BRANCH SERVICE MEMO NO. 847LG

DEALER SERVICE MEMO NO. 535

SUBJECT: Mower Chute Extension

SUBJECT: Steering Nut RE 8E Riding Mowers

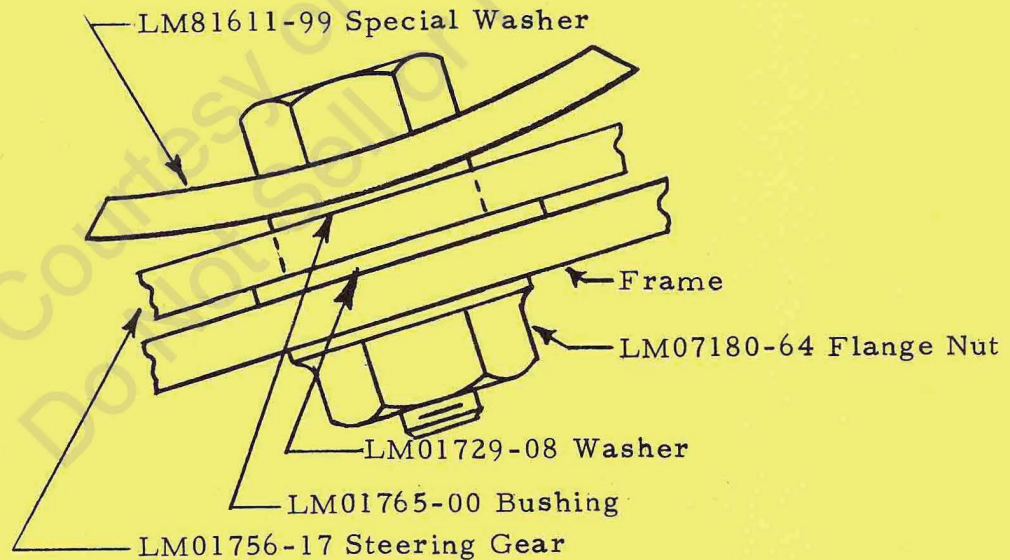
We have found a few RE 8E riding mowers where the LM07180-35 nut on the steering gear has loosened.

We have replaced LM07180-35 in this application with a center lock nut LM07180-64. We are sending each district enough of the new nuts to rework all existing units.

The illustration shows the proper sequence of assembly. Every effort must be made to correct this assembly before the unit is operated.

Instruction for Assembly of Oil Tank  
Pressure Regulating Fitting #69659-1

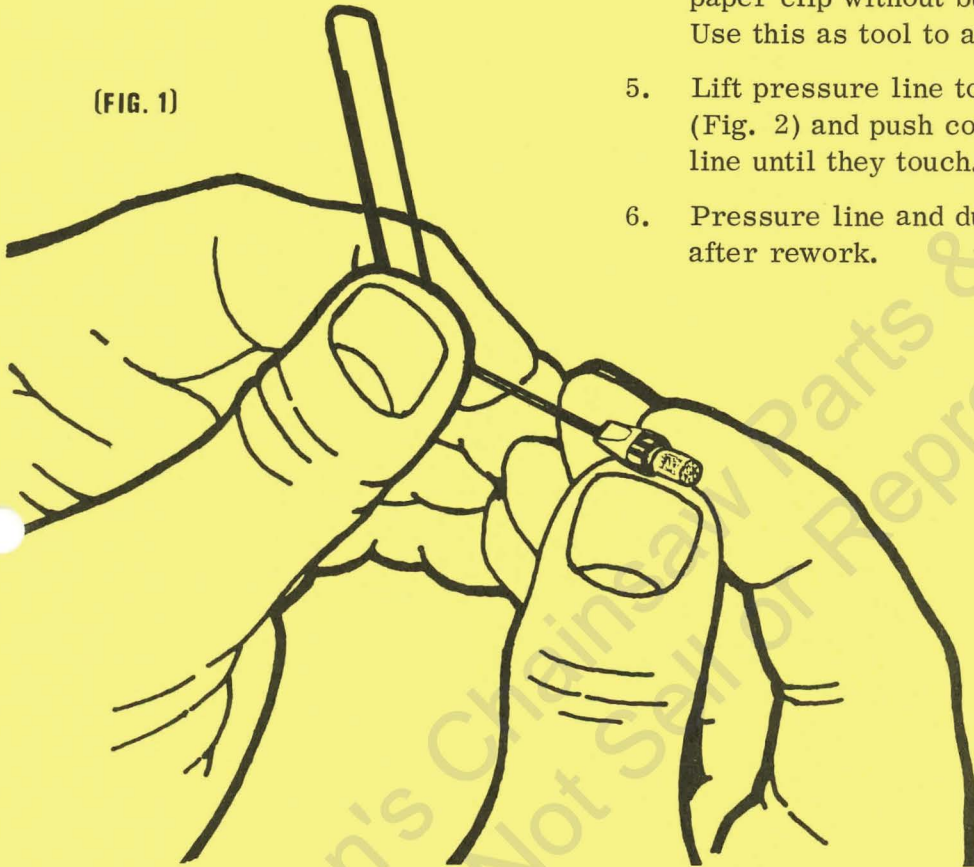
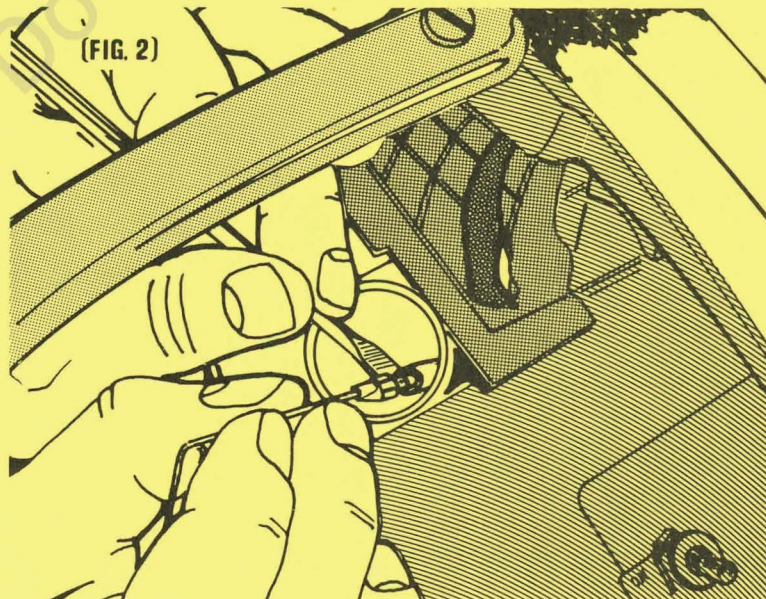
We have developed a "pressure regulating" connector which is inserted in the oil pressure line inside the oil reservoir. Now the user can forget to release the oil reservoir pressure without worrying about "puddle of oil accumulating". Neither will he have to worry about using too much oil and running out of oil before fuel.

The "pressure regulating" connector is easy to install - see accompanying photo instructions.

1. Remove oil cap to expose pressure line and duck bill check valve (Fig. 2).
2. Pull off duck bill and fitting from pressure line.
3. Remove existing fitting from duck bill and replace it with fitting #69659-1 with 1/4" of fitting exposed.
4. Insert 1/16" hex Allen wrench or large straightened paper clip without burrs into lip opening of valve (Fig. 1). Use this as tool to assemble valve to line.
5. Lift pressure line to convenient position with screwdriver (Fig. 2) and push connector with duck bill into pressure line until they touch.
6. Pressure line and duck bill must be in original location after rework.
